March 18, 2024

Huber Heights New Public Works Facility

### **ADDENDUM #1**

**1E303**

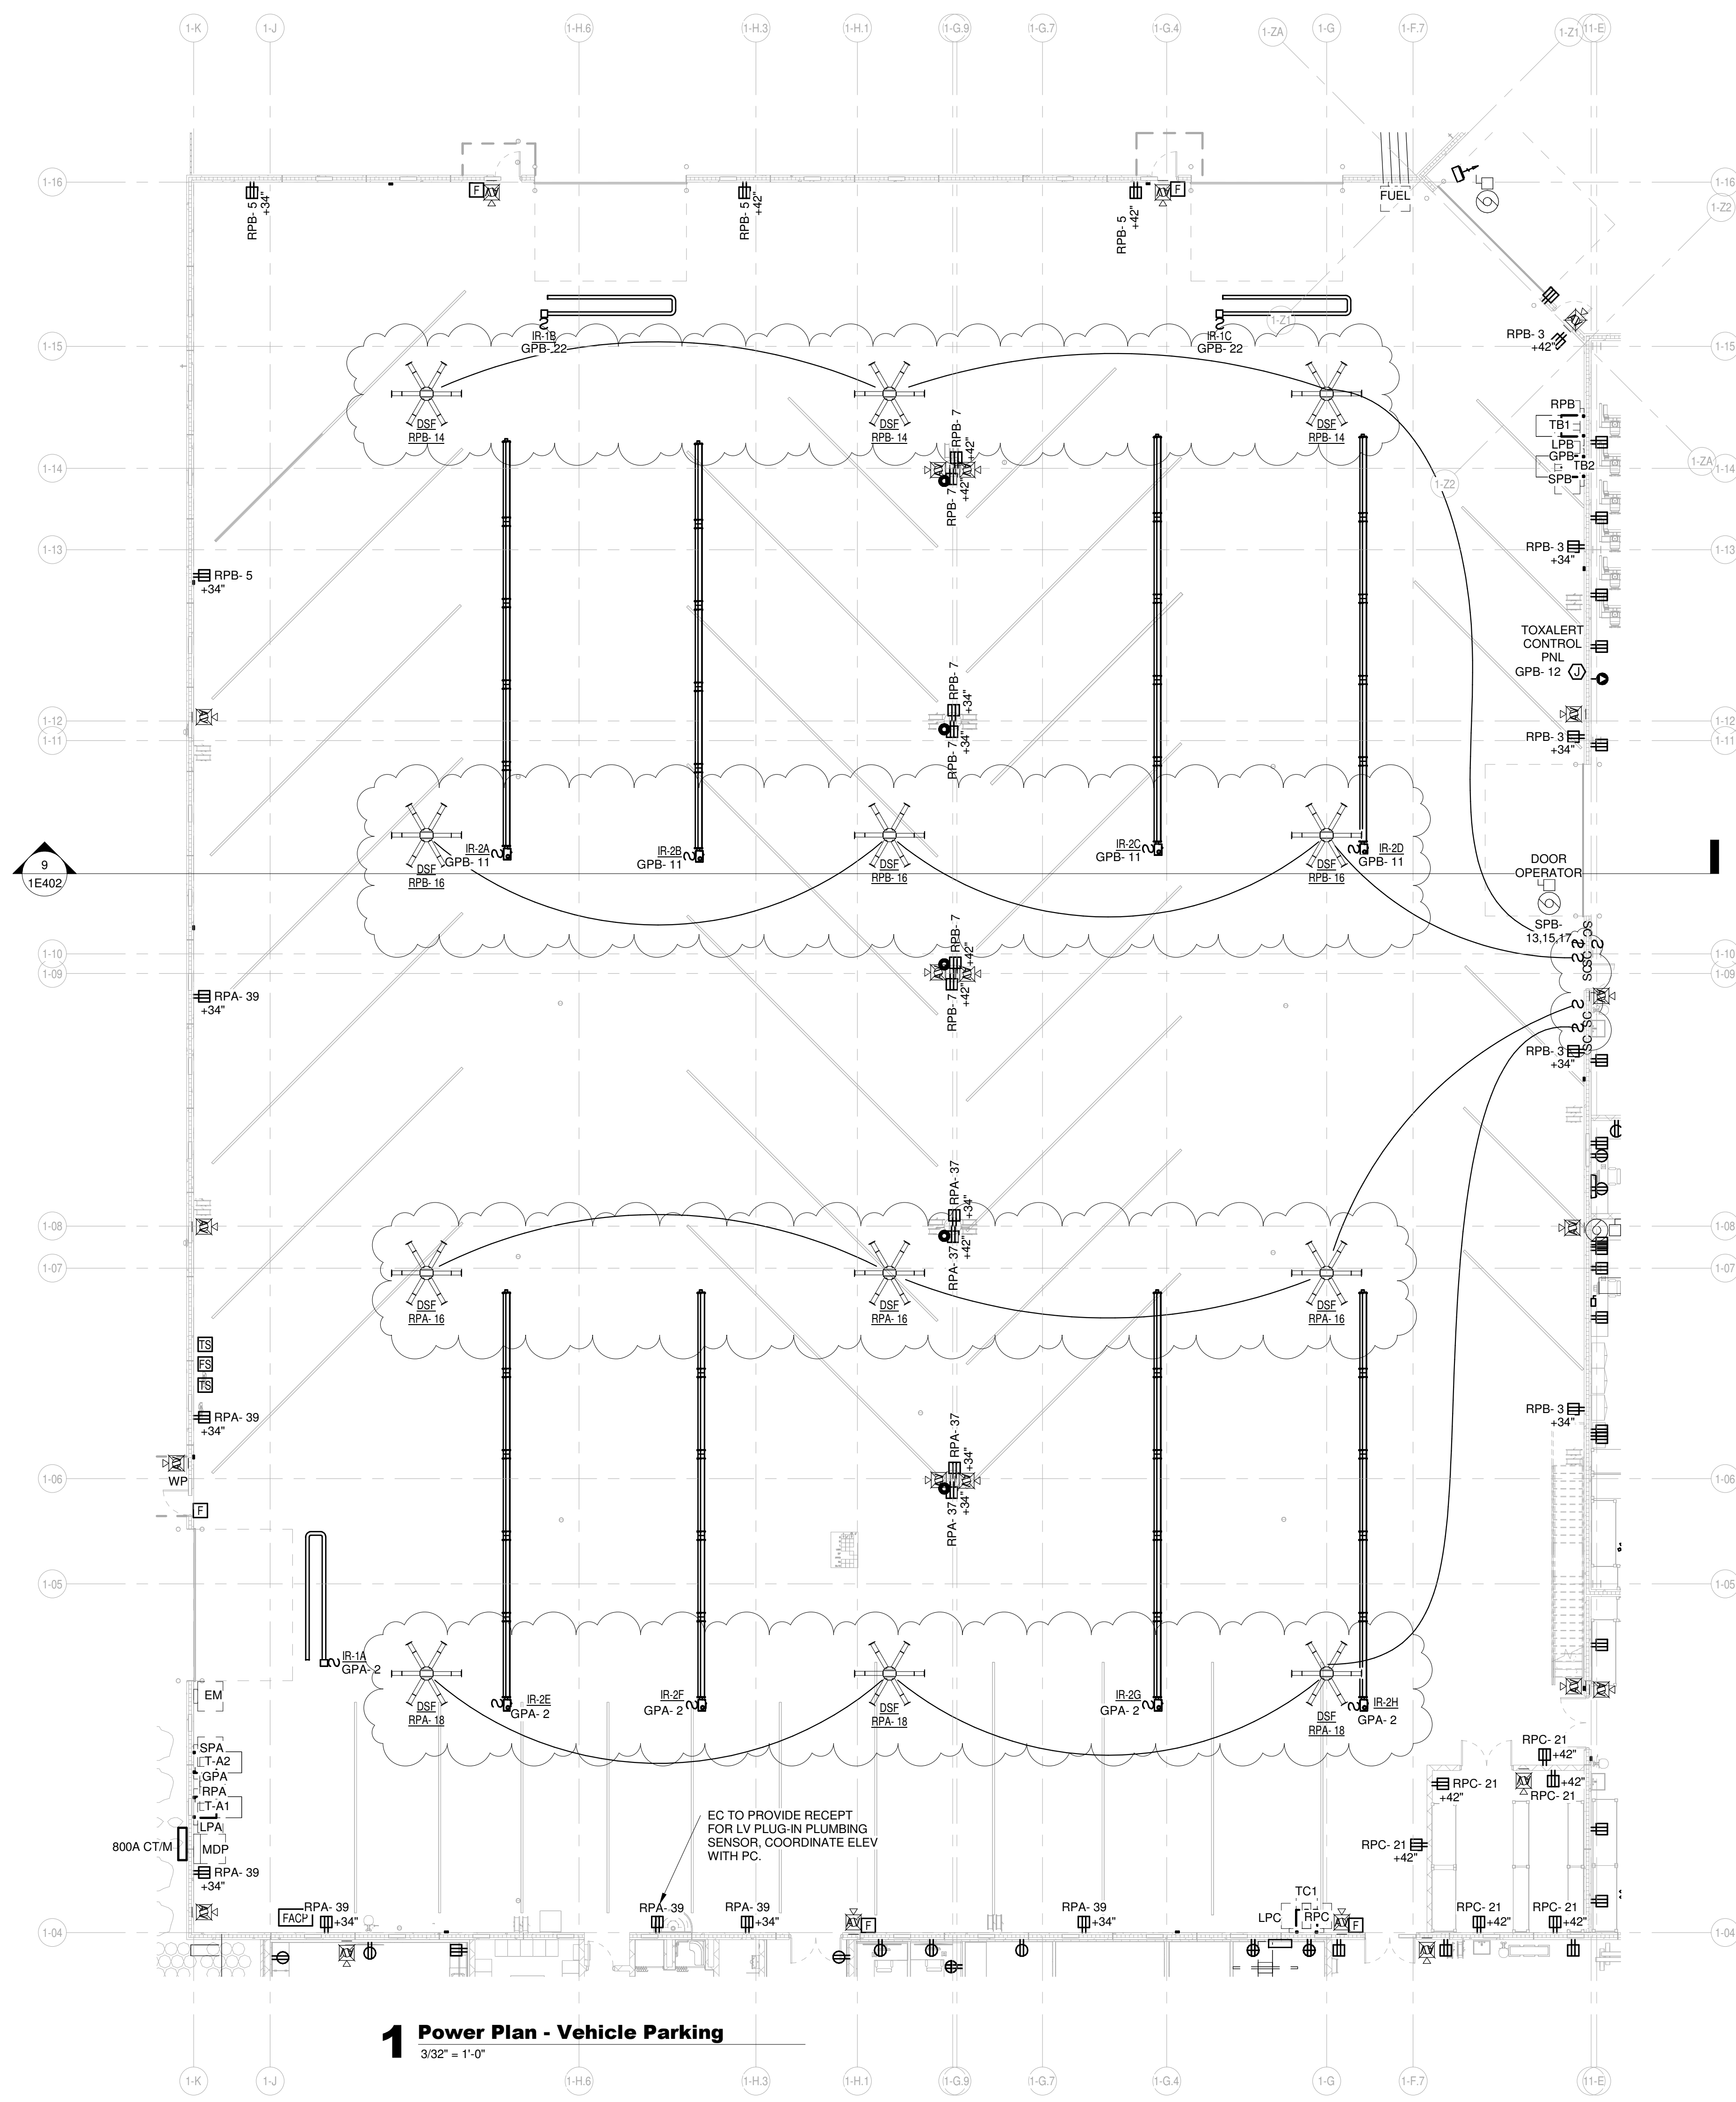
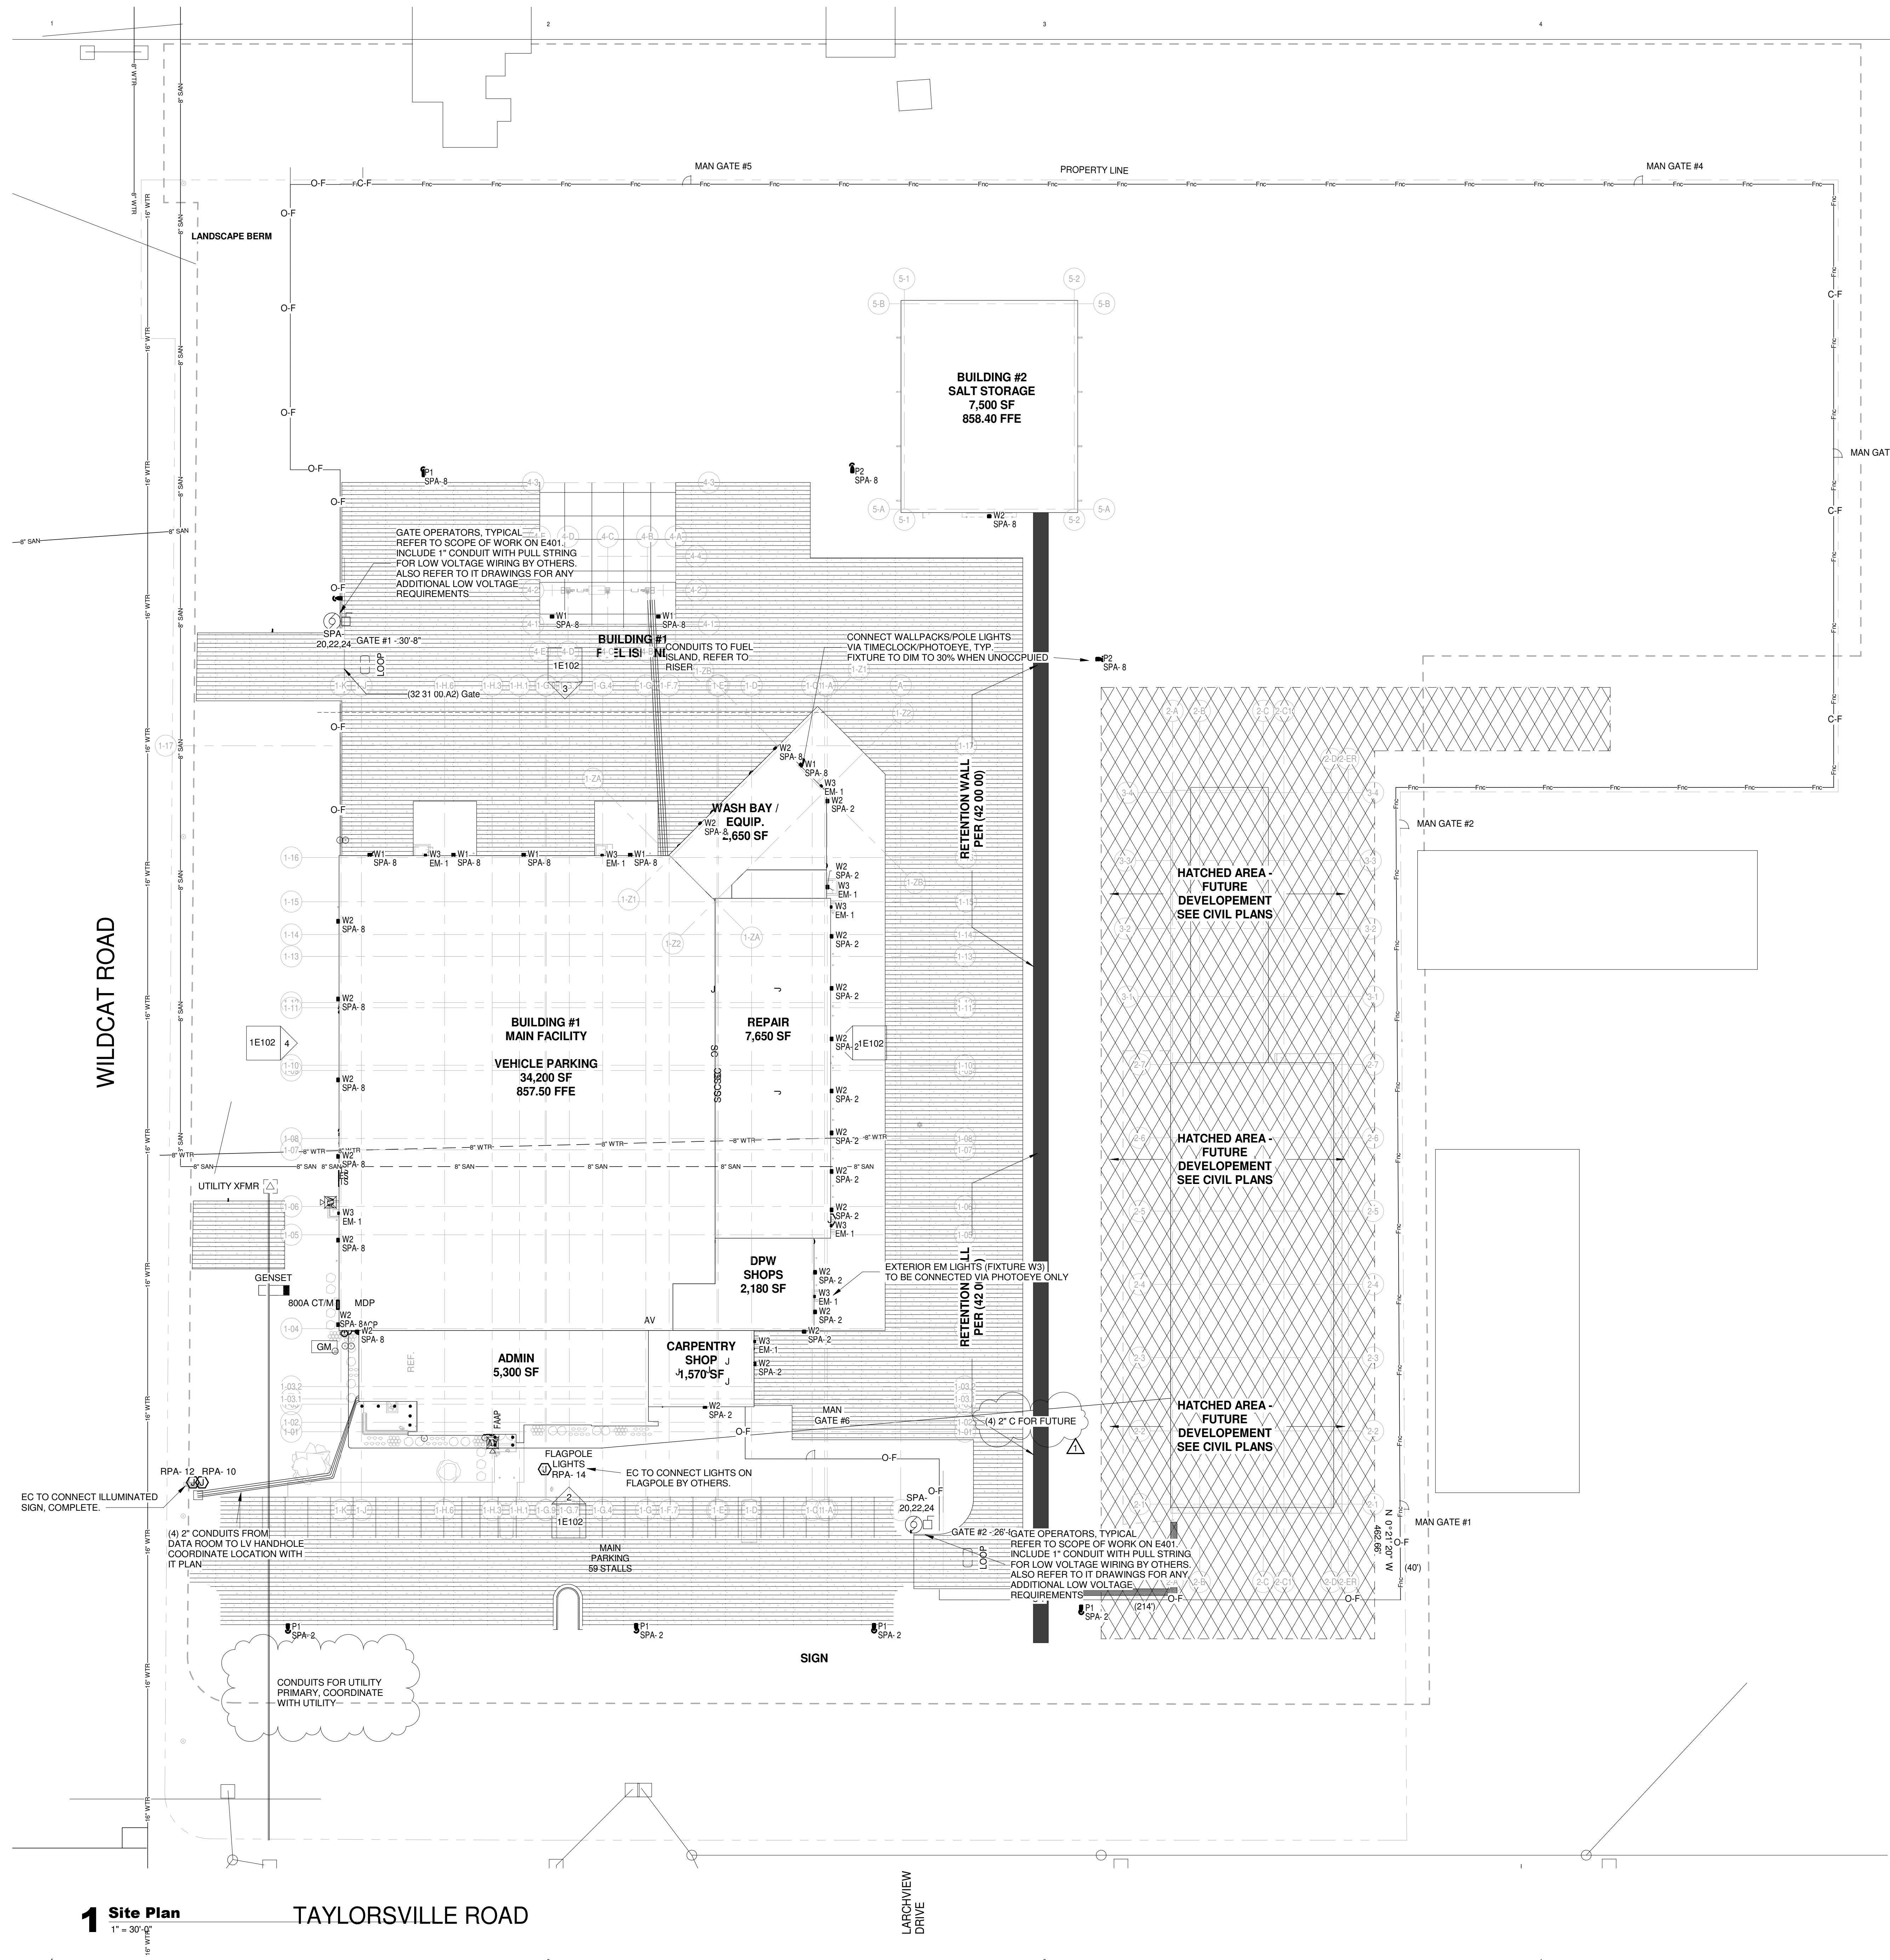
- Include (2) 4" C w/ 4-600MCM, include spare 4" conduit.
- 14. The location of branch panels 'LPC', 'SP2', & 'GP2' as well as transformers 'TC1' & 'TS' are not shown on the electrical drawings. Where are these located?**

- LPC/TC1 to be located next to panel RPC on sheet 1E303. TS, SP2, and GP2 removed from scope. Refer to updated sheet 1E501.
- 15. Panel Schedules are missing for 'FUEL' and 'LPC', please provide?**
